CITY OF LAUREL HISTORIC DISTRICT COMMISSION

EIGHT HUNDRED NINETY FOURTH MEETING
TUESDAY – SEPTEMBER 22, 2026– 6:00 P.M. - REGULAR
AGENDA

EIGHT HUNDRED NINETY THIRD MEETING
TUESDAY – JULY 21, 2026– 6:00 P.M.
MINUTES

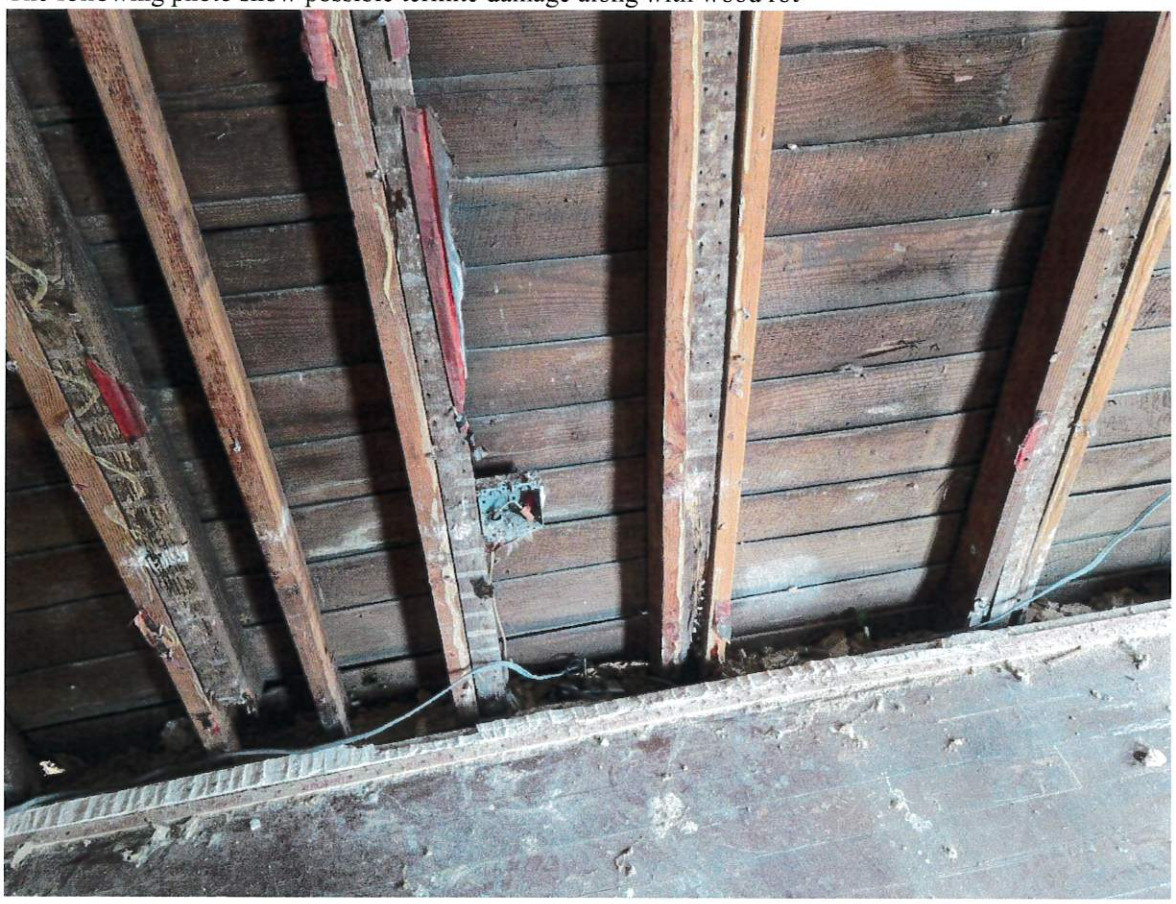
The following photo show possible termite damage along with wood rot

The previous repairs to the existing wall studs are failing. I would like to note that we were unable to access the crawlspace due to overgrowth and safety concerns. We discussed with the contractors that an strucutal engineer must evaluate the situation and provide a stamped report to the Historic District prior to any more demolition work taking place.
